Entergy Nuclear Generation Company  
Pilgrim Nuclear Power Station  
600 Rocky Hill Road  
Plymouth, MA 02360

December 8, 2000  
ENV1.00.020

**Re: Response to 6/9/00 §308 Letter and to Other §316(b) Questions  
Raised at the Meeting of 9/27/00**

## Responses to EPA Questions and Comments on Pilgrim 316 Demonstration

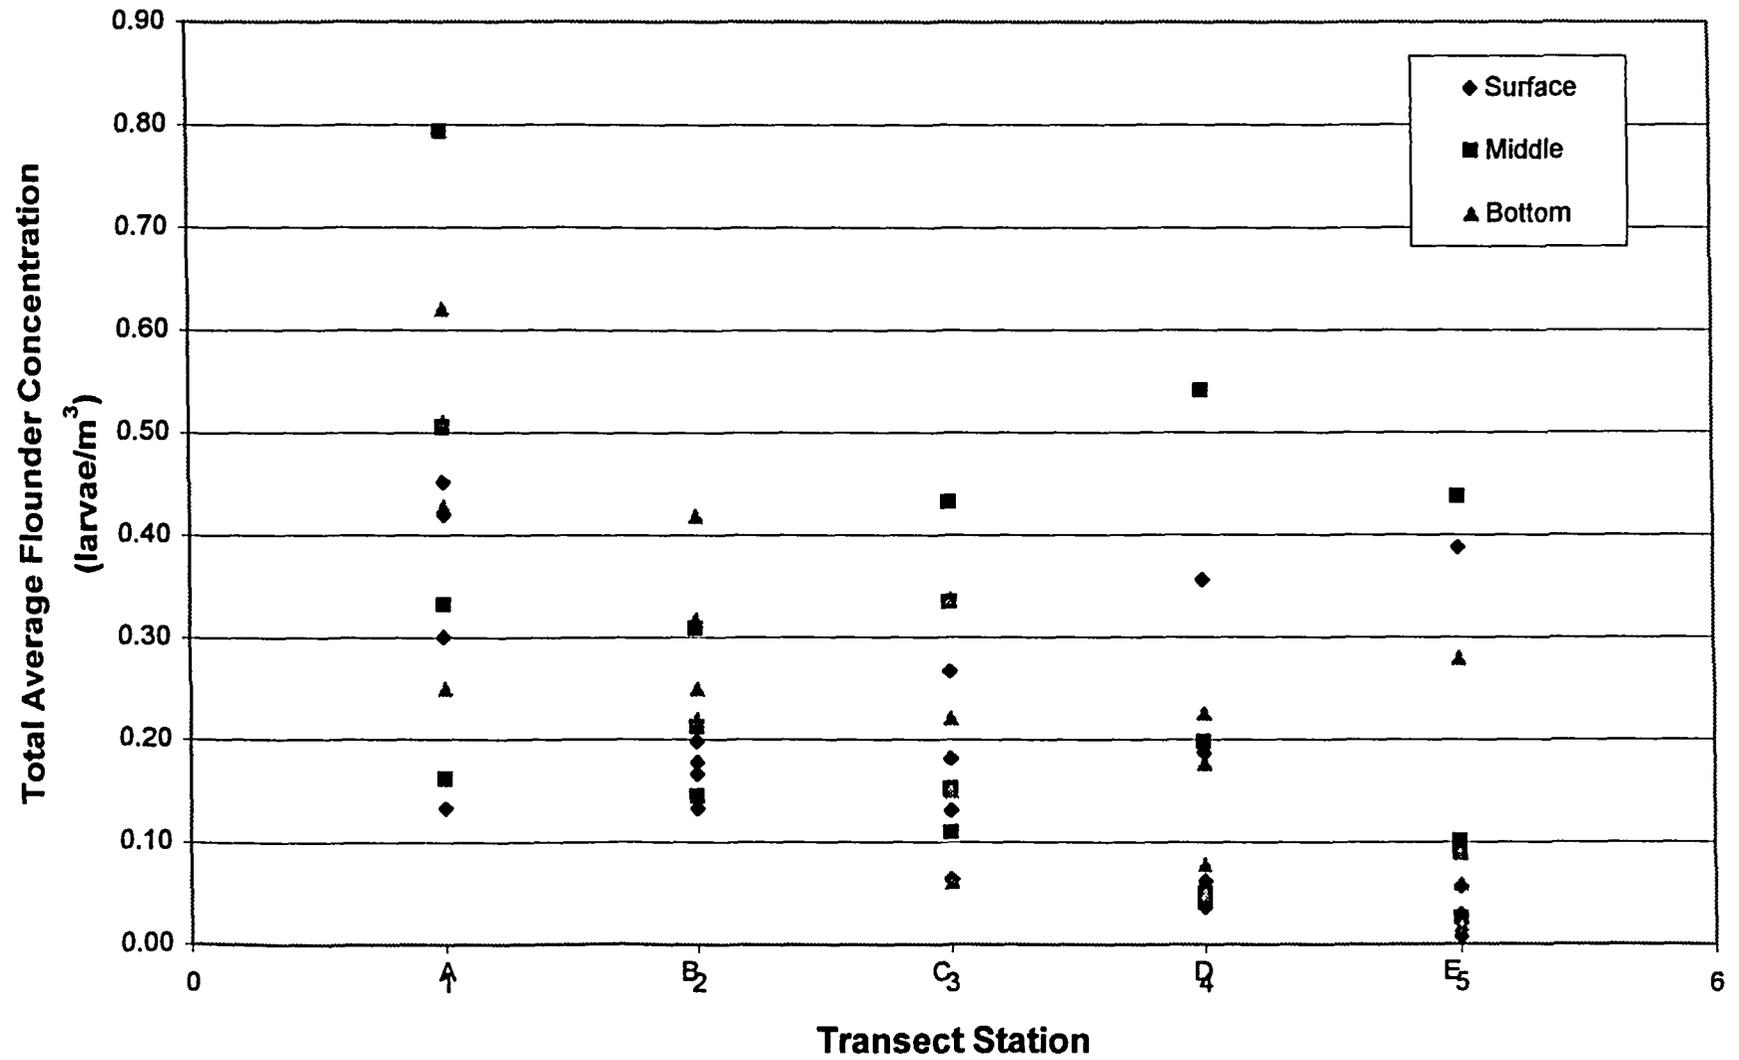
***EPA Question: Why is the number of cunner in the impact predictions greater than the cunner population?***

**Response:** The cunner population in the immediate vicinity of PNPS, along the intake breakwater, was estimated in 1992, 1994, and 1995 using tagging and recapture programs. These estimates are likely conservatively low primarily due to the difficulty of obtaining representative samples from the breakwater rock substrate. The number of cunner impinged was estimated to be 0.7% - 3% of the population. These estimates are likely high because of (1) the conservative underestimate of the population and (2) the assumption of 100% impingement mortality. Studies from 1989-1998 indicate an average survival rate of 43% for impinged cunner.

The calculated number of adult equivalents associated with cunner eggs and larvae entrained is higher than the estimated local population. A portion of the explanation for this is the conservatively low estimate of the local cunner population. However, it is likely that the most important reason is that (as discussed in the response above) cunner

eggs and larvae are carried to PNPS by the bay-wide current pattern. This means that it is more appropriate to compare the adult equivalents associated with entrainment against a regional, rather than a local, population. This comparison indicates that the entrained adult equivalents represent less than 1% of the regional cunner population.
